**Subject: Submission of Information Requirements and Required Clarifications Associated with the Flemish Pass Exploration Drilling Program: Round 2**

**Responses to Information Requirements and Clarifications – Round 2**

**For  
Flemish Pass Exploration Drilling Program  
(CEAR 80129)**

**Eastern Newfoundland Offshore Exploration Drilling Project  
(CEAR 80132)**

**Figure 1 Special Areas Intersecting with Project Area ELs and Zones of Influence**

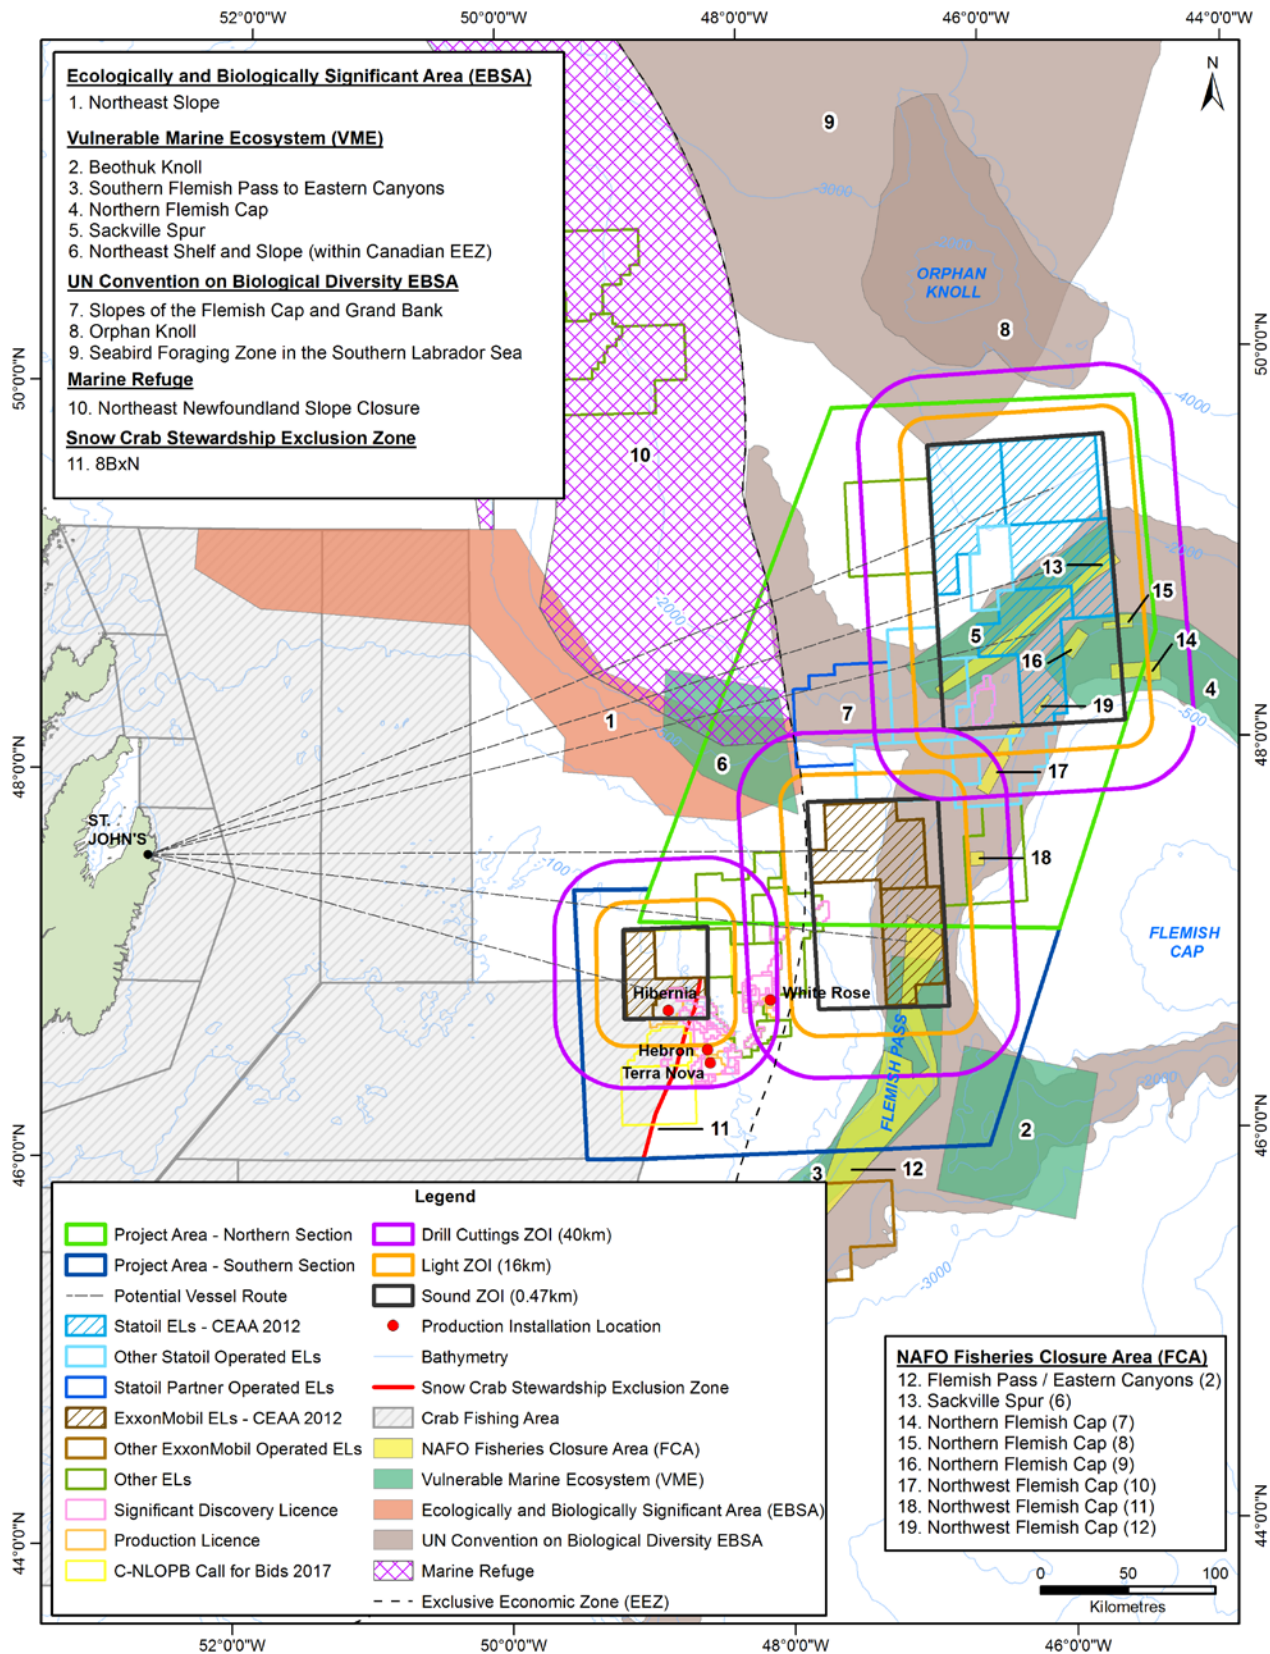
Consolidate the information from the EIS, IR-39 and also the EIS Addendum for the addition of exploration licence 1134 to provide one table and one figure depicting distances to special areas that could be affected by the Projects.

The figure, similar to Figure 11-2 in the EIS, should depict all the special areas that overlap with the project area as well as with the potential vessel and aircraft routes. The figure should also include any special areas that, while not directly overlapping with the project area or vessel and aircraft routes, may be within the zone of influence for effects of routine Project activities.

Table 1 and Figure 1 below consolidates information from the Environmental Impact Statement (EIS), Table 6 from the original response to this Information Requirement (IR) and Table 4.17 from EIS Addendum associated with the ExxonMobil Canada Ltd. (ExxonMobil) exploration license (EL) 1134. Figures 1 and 2 also outline the zones of influence (ZOI) associated with drill cuttings, light and noise, which is also applicable for the response to IR-40-2. For details associated with ZOI refer to the response to IR-40.

As outlined in Figure 1 in the response to Information Request (IR) IR-39-2, a 40 km buffer was applied to the outer boundaries of the exploration licenses (ELs). In lieu of applying the 40 km buffer to individual ELs, which would result in seven separate ZOIs, three ZOIs were selected and grouped together adjacent to the ELs. This approach is very conservative, as the maximum boundary extents were selected.

Figure 2 Figure 4-29 of ExxonMobil’s Appendix E

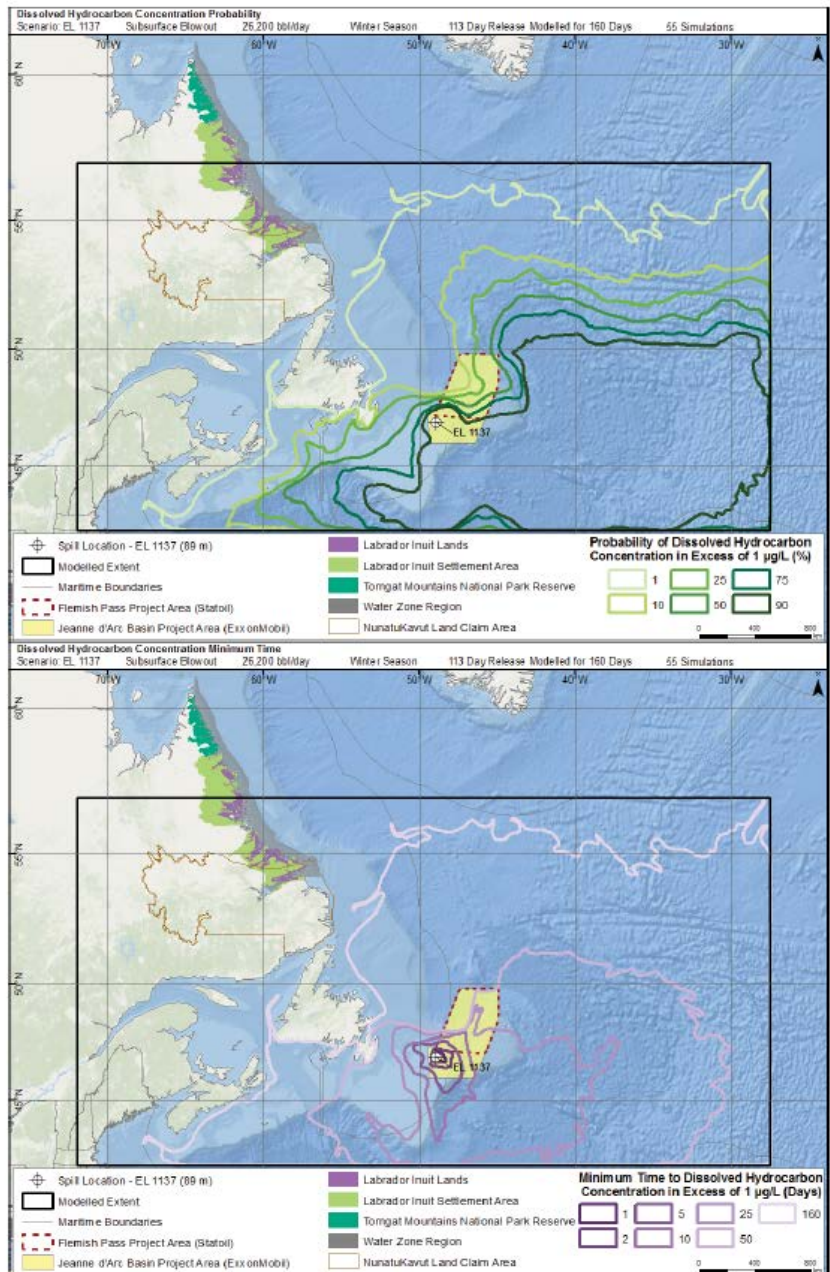
The proponents' response also states that oil exposure greater than 1 gram per meter squared is not anticipated to reach the Gulf of St. Lawrence, however figures 4-10, 4-11, 4-12, 4-29 and 4-30 of Eastern Newfoundland Appendix E and figures 15-7, 15-8 and 15-20 of the Eastern Newfoundland EIS appear to show probability of oil exceeding thresholds within the Gulf of St. Lawrence.

Provide project-specific discussions of the probability that oil from a vessel spill or well blowout could reach the Gulf of St. Lawrence and describe the potential environmental effects, taking into consideration existing modelling results which appear to show oil within the Gulf of St. Lawrence.

Fisheries and Oceans Canada (DFO) defines the Gulf of St. Lawrence in the *Gulf of St. Lawrence Integrated Management Plan* (DFO 2013), which is also included as Figure 1 below. Based on the boundaries of the Gulf of St. Lawrence outlined in Figure 1, the Operators concluded that applicable figures in Appendix E (i.e., 4-10, 4-11, 4-12, and 4-30) and the EIS (i.e., 15-7 and 15-8) do not show oiling within the Gulf of St. Lawrence. However, the Operators recognize that Figure 4-29 in Appendix

E does result in a low (i.e. less than 1%) probability of shoreline oiling and is associated with a minimum time of 100 days (Figure 2). As mentioned in Section 4.1.3 of Appendix E, it is important to note that the stochastic figures do not imply that the entire contoured area would be covered with oil in the event of a single release, and oil that is predicted to make contact with shorelines is expected to be highly weathered. These spill scenarios are considered representative of credible worst-case with no mitigation measures.
